Golden Gate Bridge & Highway District

Investigation of Criticism of Foundation by
DR. BAILEY WILLIS

Report of Building Committee

South Pier - Investigation of criticism
of foundation by Dr. Bailey Willis, Pro-
fessor Emeritus of Geology, Stanford
University.

FIG. 1

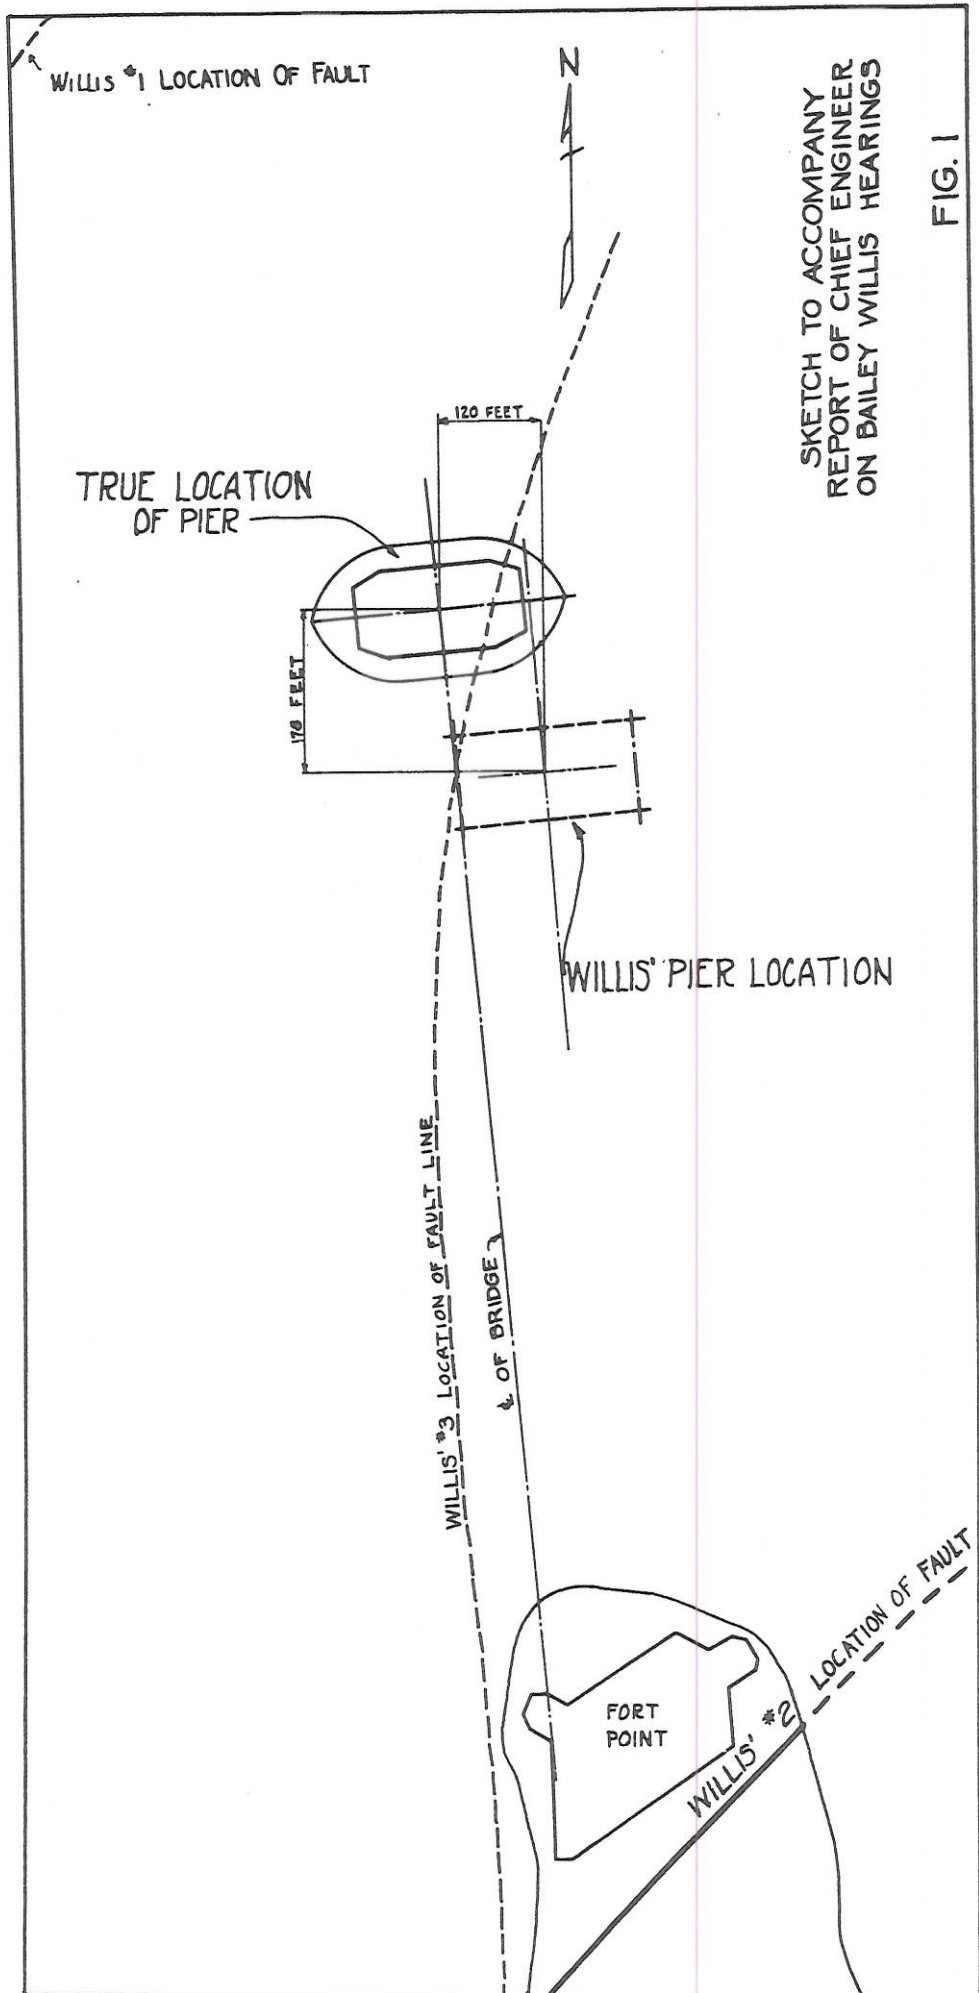
sandstone and the fault between the sandstone and the serpentine. These projections are upon an enlargement of a section of a sheet of the Coast and Geodetic Survey. (Exhibits 9, 9-a and 9-b.) The map as originally presented projected all these features and there was but one fault line. It was thereafter demonstrated that Professor Willis had made an error in location of the south pier, that he had located it by "general information", that he had placed the pier as near as he could on the diagram "not considering that for geological purposes that the exact location of the pier was a matter of very much consequence", and that he had found, as he had been told after introduction of the map, that the pier was located 178 feet north and 120 feet west of the location which he had shown. (Transcript 3, page 8.) Exhibit attached. (Fig. 1.)

The fault line projected on Professor Willis' original map would have passed directly through the south pier correctly located. When Professor Willis re-ramped the map he moved the fault line west and this represented the progress of his studies in the interval between September 28th and October 22nd which had also developed other faults which were delineated on the map showing the correct location of the pier. (Transcript 3, page 12.)

SKETCH TO ACCOMPANY
REPORT OF CHIEF ENGINEER
ON BAILEY WILLIS HEARINGS

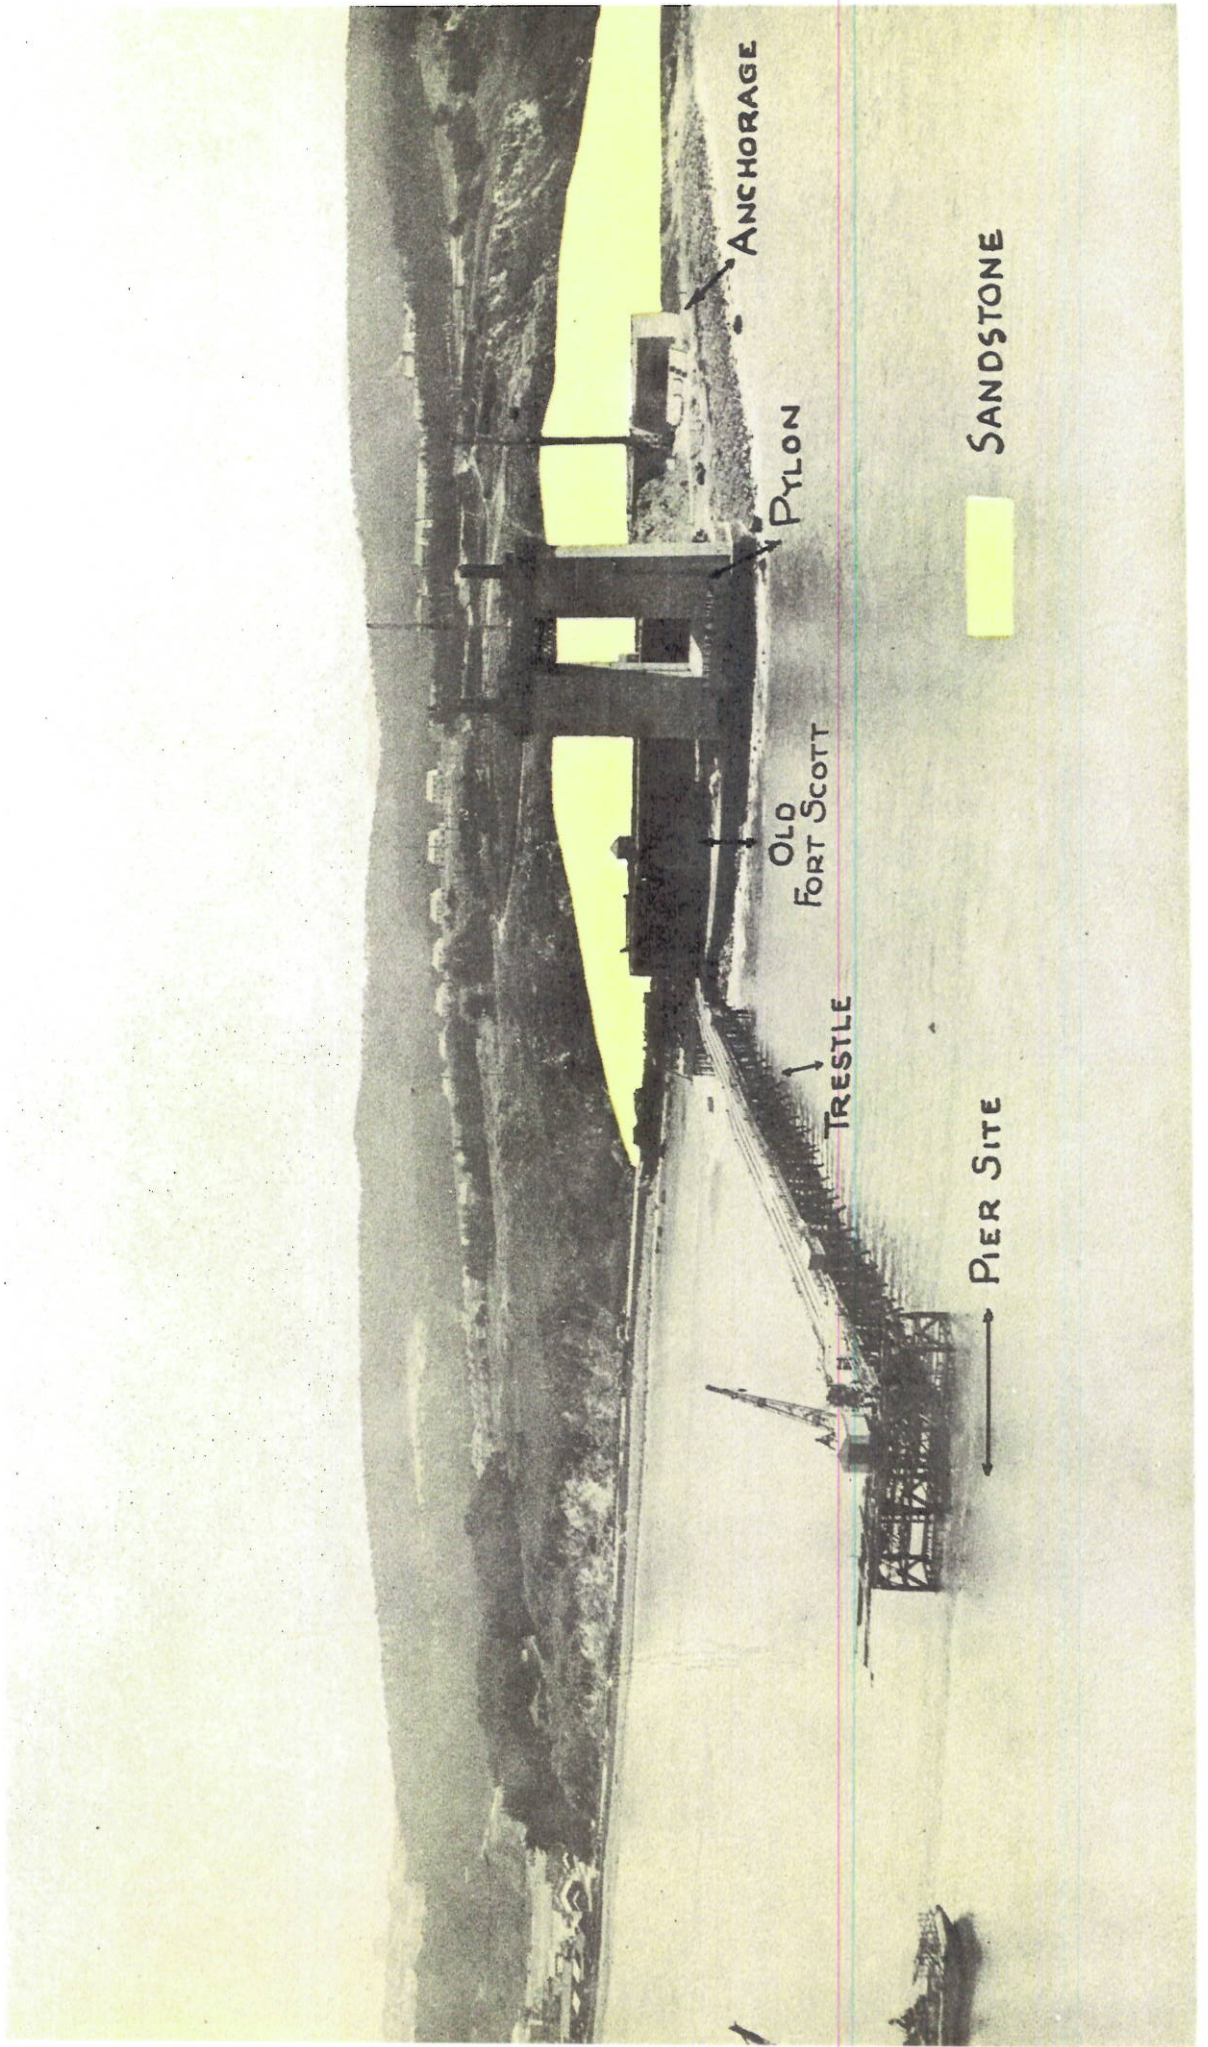
Professor Willis referred to a disparity in profile or contour of the formation northwest of the south pier site, claiming a difference between the profiles as indicated by contours in the surveys of 1895 and 1920, and that this disparity indicated a recession due to slides. These findings were checked and it is demonstrated that Professor Willis was again in error and that there had been no substantial, if any, changes in the contours between 1895 and 1920. (Transcript 3, page 57 and exhibits.) Professor Willis, admitting one error, commented:

"On the east-west profile, we found that I had read an obscure two as a one." (Letter November 7, 1934, addressed to Chairman, Building Committee.)

He also claimed that there was no error in his delineation of the north-west profile, but this does not accord with the checking of the District engineers. The misreading of the obscure numeral by the Professor, as the numerals related to fathoms, made a difference of 60 feet. (Transcript 3, page 62.) Exhibit attached. (Fig. 3)

south of the anchorage. This sand-stone strikes east and southeast from the anchorage and slopes south. This layer could not, therefore, underlie the pier. Professor Willis had not seen the exposure in the excavation for the anchorage. (Transcript 2, page 27.) After this fact was developed Professor Willis claimed that there was a serpentine intrusion and that there is a sand-stone underneath the serpentine upon which the anchorage, the Fort and the pylons rest and which underlies the south pier. Exhibit attached. (Fig. 3.)

SKETCH TO ACCOMPANY
 REPORT OF CHIEF ENGINEER
 ON BAILEY WILLIS HEARINGS
 FIG. 2

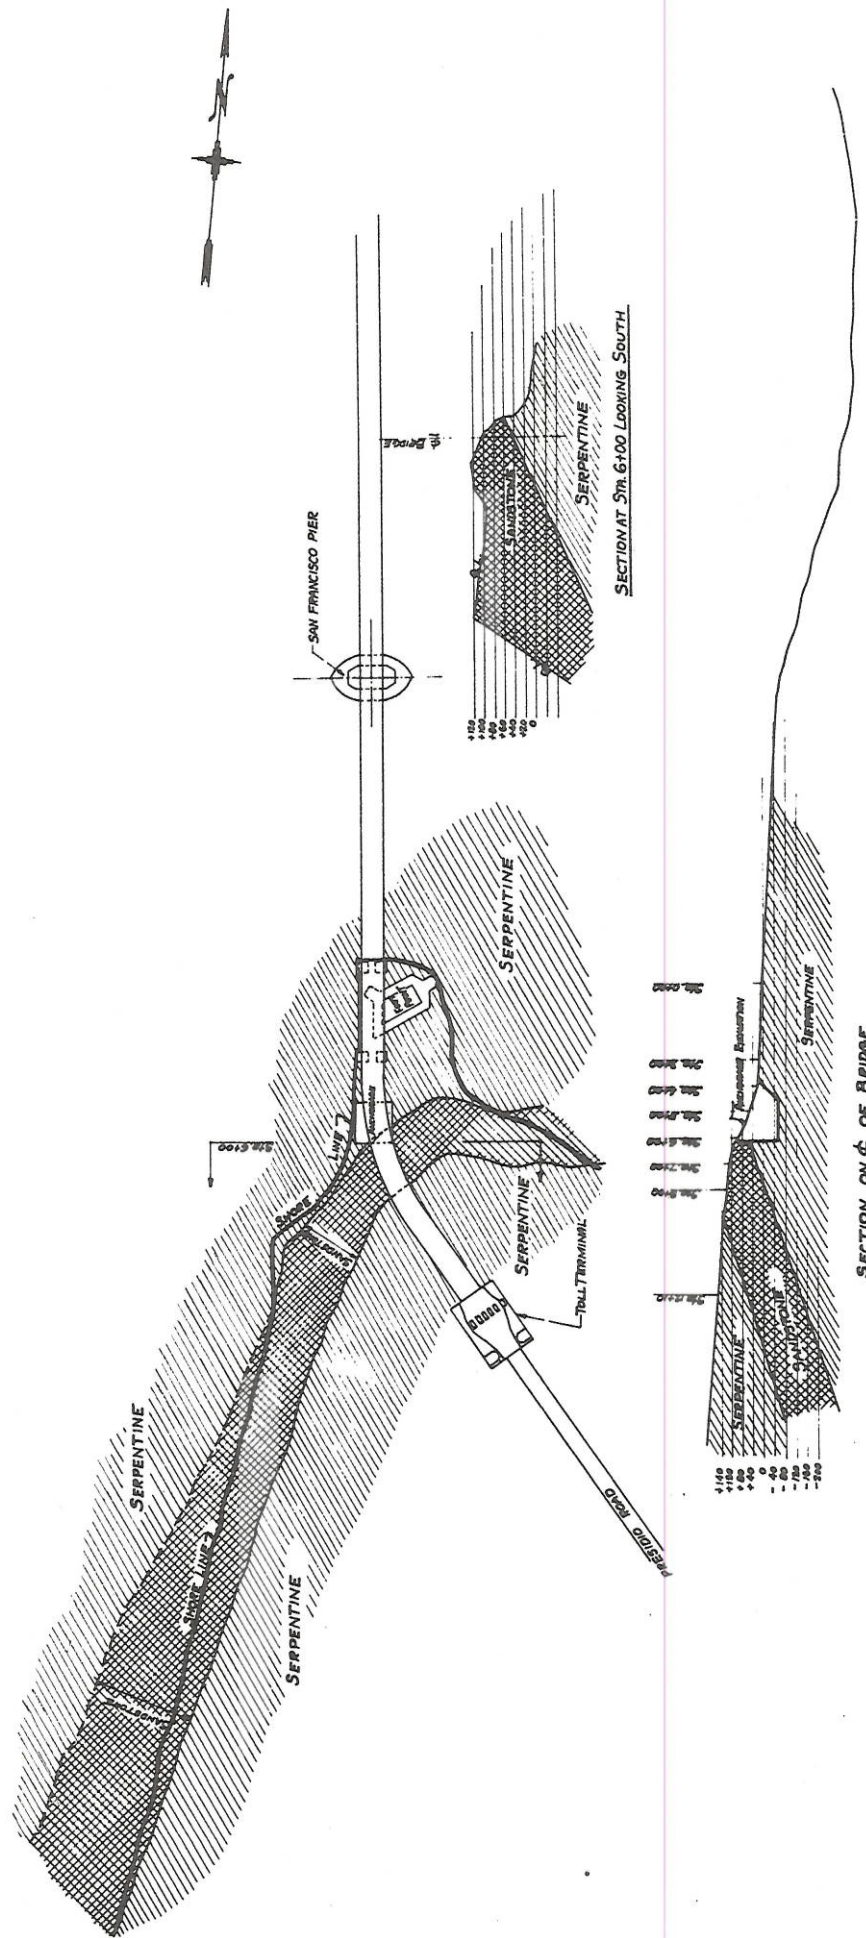
As may be surmised, if not definitely so stated heretofore in this report, Professor Willis claims that the alleged sand-stone, which he has projected as extending to the west of and beyond the site of the south pier, slopes southeast under the pier. He asserts that the serpentine superimposes this sand-stone, that the structure is faulted between the sand-stone and the serpentine, that the slope goes off steeply and that the pier which is to support the greatest bridge ever built is to rest upon a slippery incline on the edge of an abyss (from a statement accompanying a letter addressed to W. W. Felt, Jr., Secretary, dated October 7, 1934, signed "Bailey Willis".) The existence of this sand-stone is based upon analogy. There has been no taking of specimens and in so far as that particular sand-stone is involved, it is a guess. (Transcript 2, pages 28, 30, 36, - (lines 5-13, 18-22) and 39.)

There is sandstone which is exposed on the cliff and in the excavation

SKETCH TO ACCOMPANY
 REPORT OF CHIEF ENGINEER
 ON BAILEY WILLIS HEARINGS
 FIG. 4

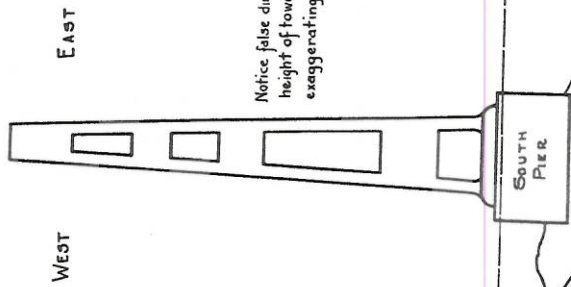
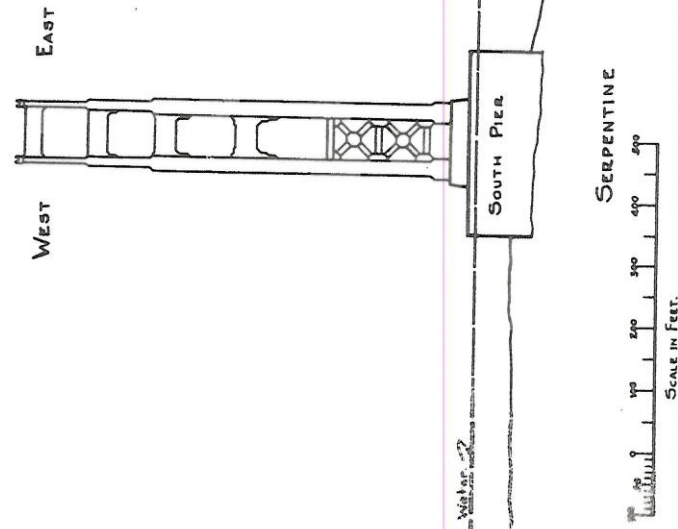
Professor Willis projected this underlying sandstone in an east-west section through the south pier in an article appearing in the Argonaut, October 19th, pending the hearing. It developed at the hearing, October 22nd, that the section was erroneous. This section was published in the Argonaut as an ocular demonstration that the south pier would rest on serpentine superimposed upon a slippery fault over sandstone. It was not only erroneous as to the depth of the water, but exaggerated the slope. If the pier was drawn to scale, the sandstone should be exposed within approximately 30 feet below the westerly end of the pier and within approximately 75 feet of the easterly end of the pier.

He indicated the depth of the channel to be 340 feet in this section, when, as a matter of fact, it is 241 feet, being a difference of approximately 100 feet. Exhibit attached. (Fig. 4)

Notice false dimensions, in depth and location of channel, height of tower, and size of pier for the purpose of exaggerating alleged instability.

ACTUAL SECTION.

NATURAL SCALE
USED FOR DISTRICT
MODEL OF SITE

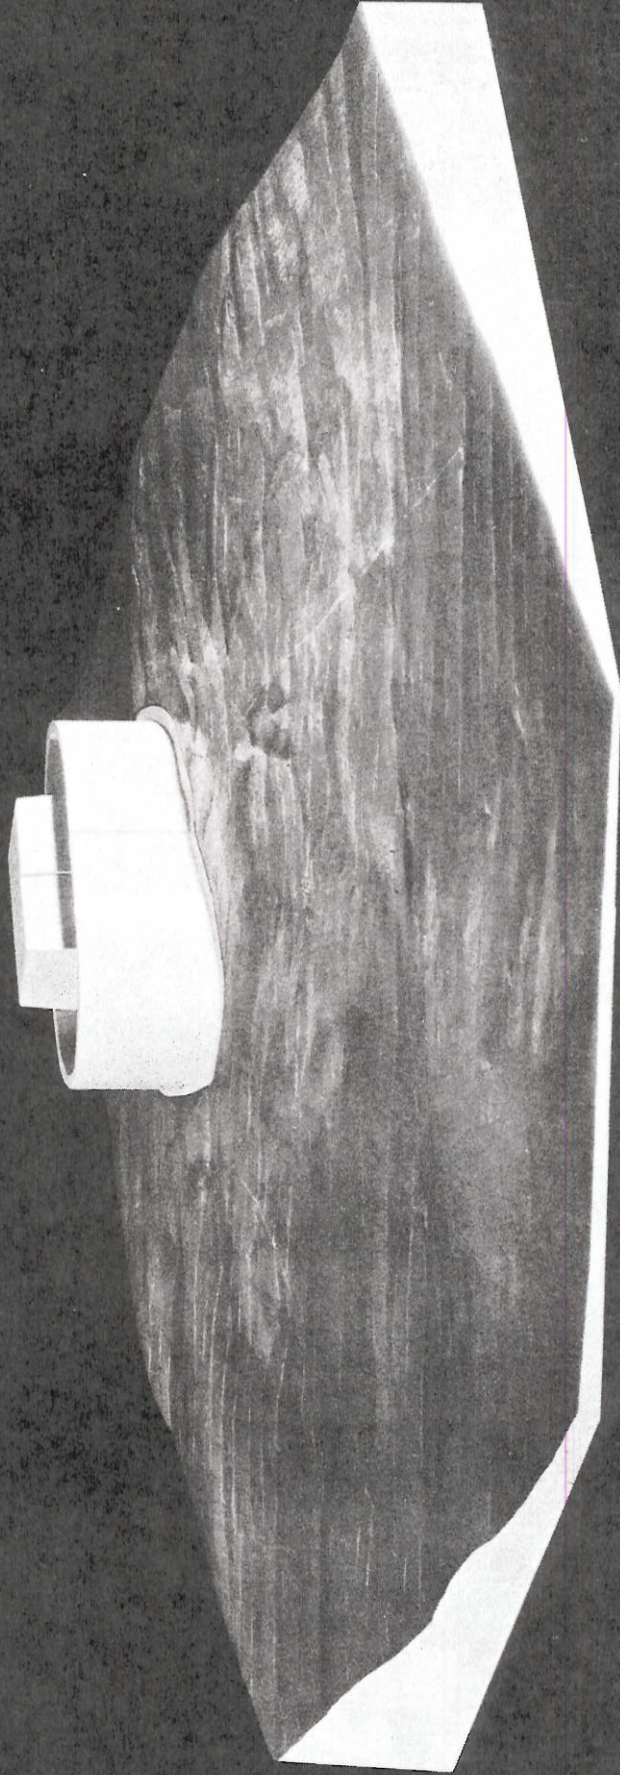
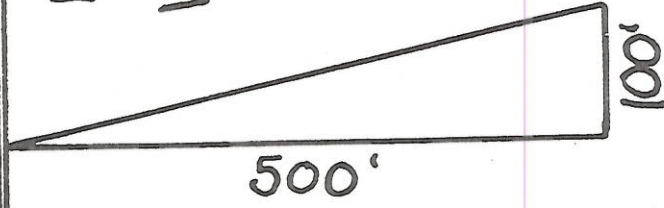
Professor Willis also exhibited a model of the formation on which the pier is located, the design being based upon Coast and Geodetic Survey maps (transcript 3, page 44), but with a peculiarity that the vertical was exaggerated 5 to 1. (Transcript 2, page 42.) This would have the effect of increasing the slope, and, unless one may visualize the actual slope with the knowledge of an engineer, is deceptive. It is difficult to conceive the purpose, particularly if it were intended for information of the public. It not only exaggerated the slopes, but exaggerated the so-called gulleys and canyons. A print was also reproduced in the Argonaut. The south pier was projected thereon incorrectly and had the appearance of being perilously near the edge of a steep bluff. That was the effect of exaggerating the vertical. (Transcript 2, page 45.)

THIS MODEL, BY PROFESSOR WILLIS, IS ON A DISTORTED SCALE. ANY SOUNDINGS USED IN ITS MAKING WERE TAKEN FROM COAST AND GEODETIC CHARTS. FROM SUCH SOUNDINGS IT IS IMPOSSIBLE TO DERIVE SUCH DETAIL AS SHOWN HERE.

THIS MODEL IS AN EXACT REPRODUCTION ON A NATURAL SCALE OF THE SAN FRANCISCO PIER AND FENDER AND ROCK SURFACE UPON WHICH THEY ARE BASED. PIER AND FENDER MADE FROM CONTRACT PLANS. THE RELIEF MAP FROM THE 600 SOUNDINGS TAKEN BY DISTRICT FORCES.
